SERVICE BULLETIN

N° 139-663

ATA 30 - WIPER BLADE SPRAY NOZZLE REPLACEMENT

REPLACEMENT OF AW139 WIPER BLADE SPRAY NOZZLE
PN 3G3040V01151

Figure 1

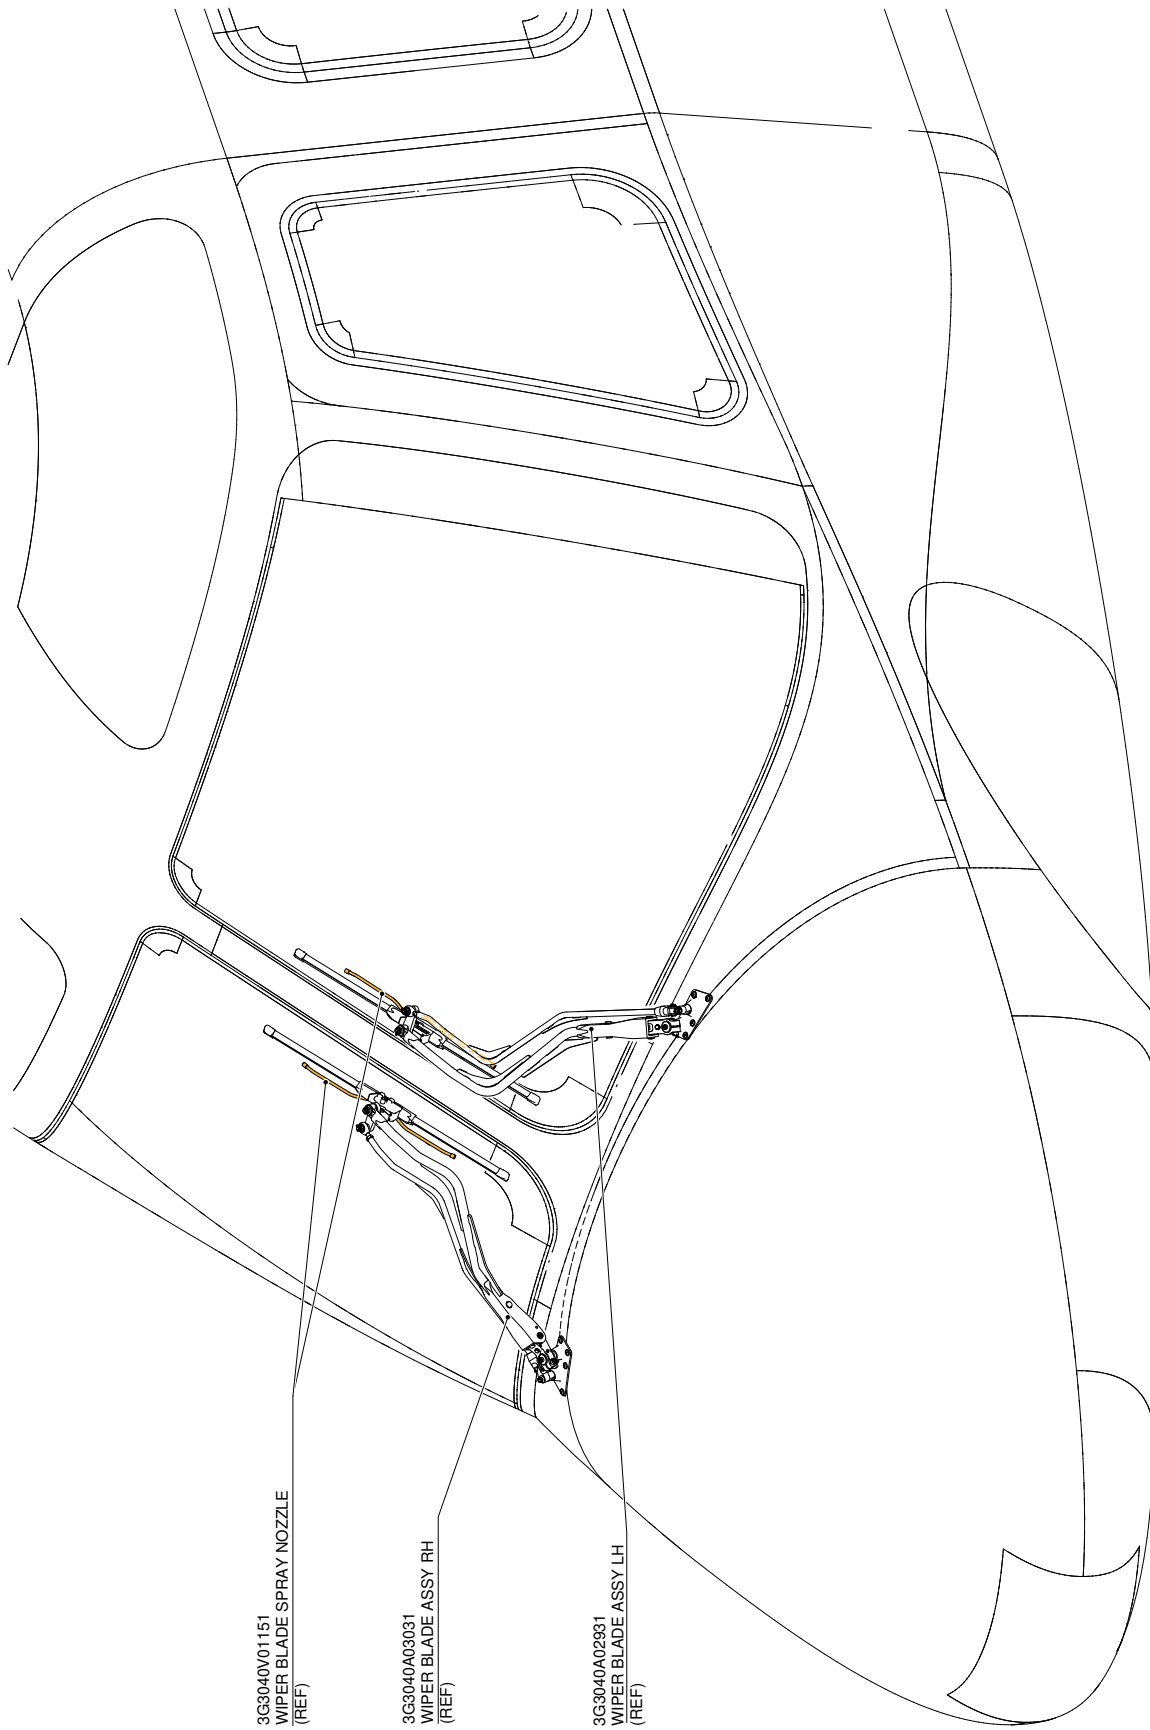
1. In accordance with AMP DM 39-A-00-20-00-00A-120A-A, prepare the helicopter on ground for a safe maintenance. Disconnect the battery, all electrical power sources and/or the external power supply.
2. With reference to Figure 1, gain access to the wiper blades area of the helicopter.
3. With reference to Figure 1 and the example pictures in SB-85-479-001 in Annex A (page 7 of 7), check the serial number of each wiper blade spray nozzle(s) P/N 3G3040V01151. If the serial number is included in the effectivity of this Service Bulletin, take a picture of the component with visual evidence of the serial number and note the required information in the table of Figure 2. Discard and locally scrap the affected component(s).

4. With reference to Figure 1 and in accordance with Aerosystems Service Bulletin SB-85-479-001 in Annex A, perform the replacement of the affected wiper blade spray nozzle(s) installed on the wiper blade assy LH P/N 3G3040A02931 and/or RH P/N 3G3040A03031.

Figure 1

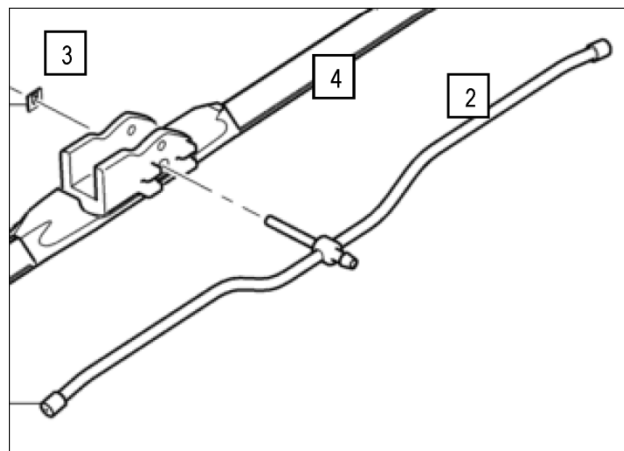
- 1) Prepare the helicopter for a safe maintenance, disconnect any power supply, refer to AMP for applicable procedures.
- 2) Remove the rubber tube (1) connected to the Wiper Blade Spray Nozzles (2) PN 3G3040V01151 (Ref. Fig. 2)
- 3) Remove the Circlip (3) PN 85-142-02 by lifting the circlip tongue with a flat-headed screwdriver (Ref. Fig. 3 and 4).
- 4) Detach the Wiper Blade Spray Nozzles (2) PN 3G3040V01151 from the wiper blade (4) (ref. fig 1).

Figure 3

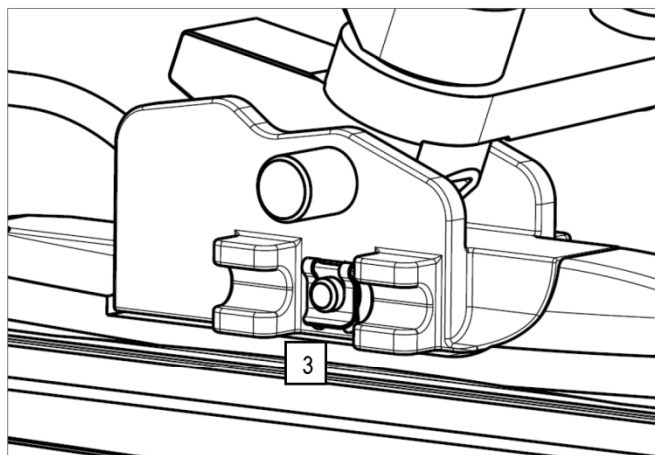
- 5) Replace the Wiper Blade Spray Nozzle PN 3G3040V01151 with a new one, install the new Circlip (3) in place as showed in Figure 3 and 4 and connect the water distribution hose (1) to the proper fitting, fixing it by means of a tiedown (5) PN A629A04HS (ref. fig 5)

Figure 5

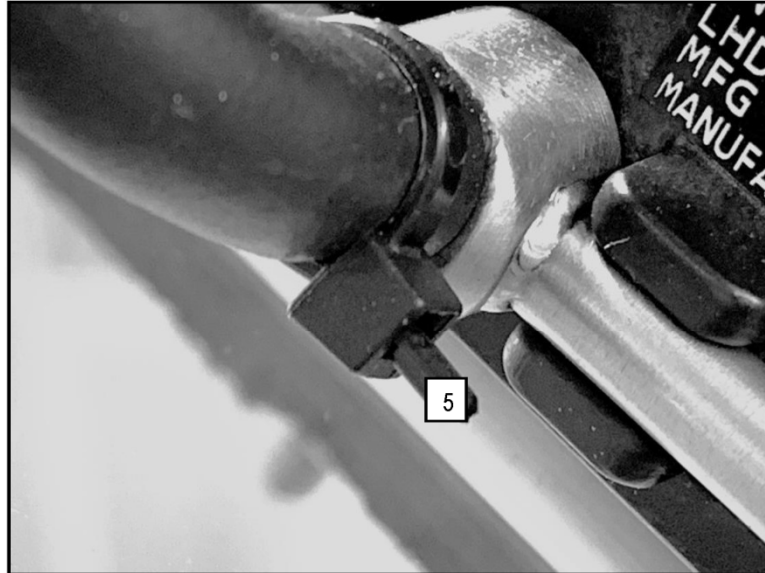
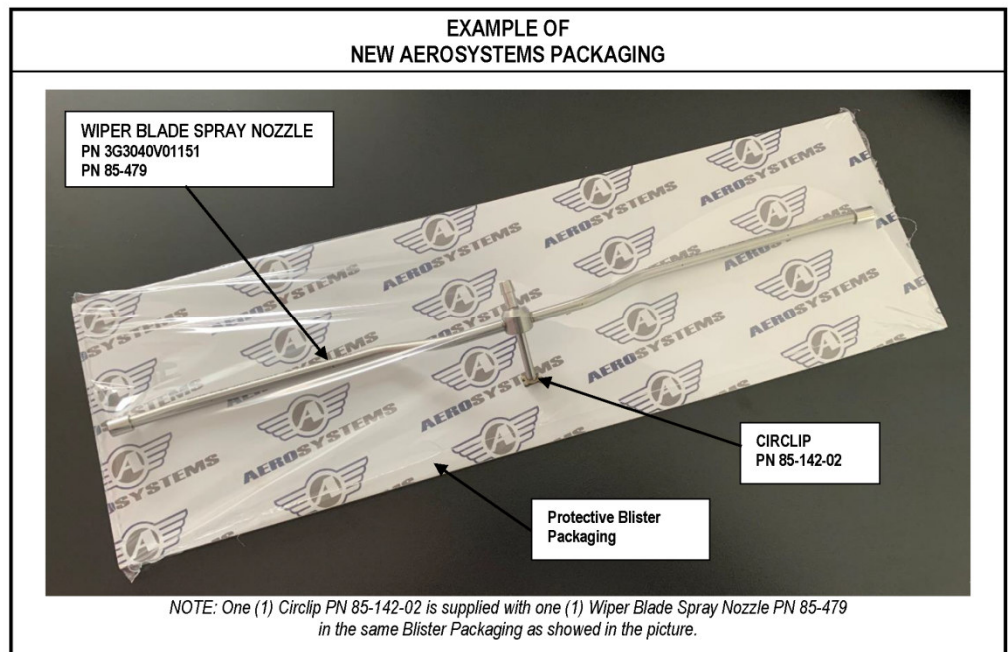
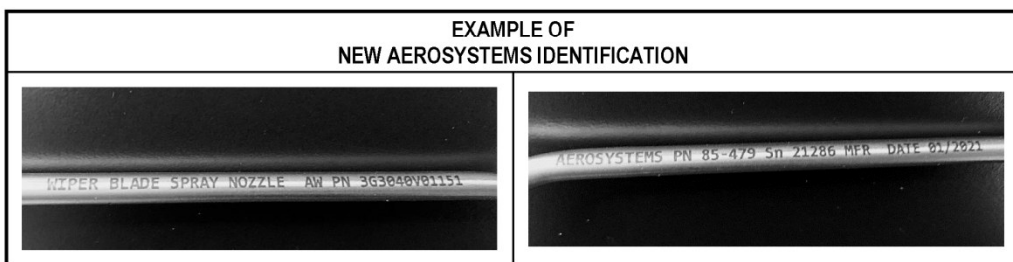
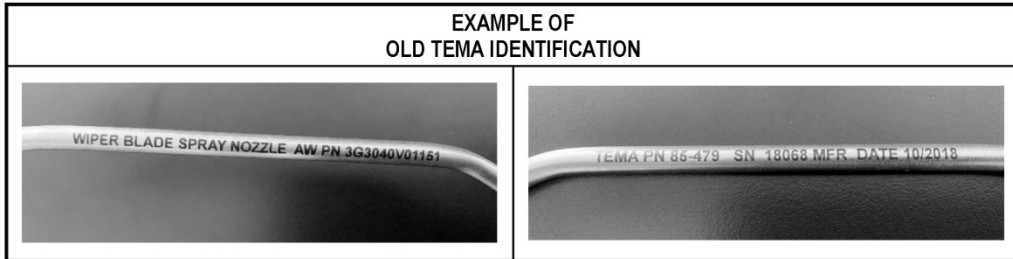
<p>WIPER BLADE SPRAY NOZZLE PN 3G3040V01151</p> <p>Manufacturer TEMA: A3848</p> <p>PN: 85-479 <u>S/N: up to 19090 (included)</u></p>	To be replaced with: 	<p>WIPER BLADE SPRAY NOZZLE PN 3G3040V01151</p> <p>Manufacturer AEROSYSTEMS: AR971</p> <p>PN: 85-479 <u>S/N: starting from 19091</u></p>
---	---	---
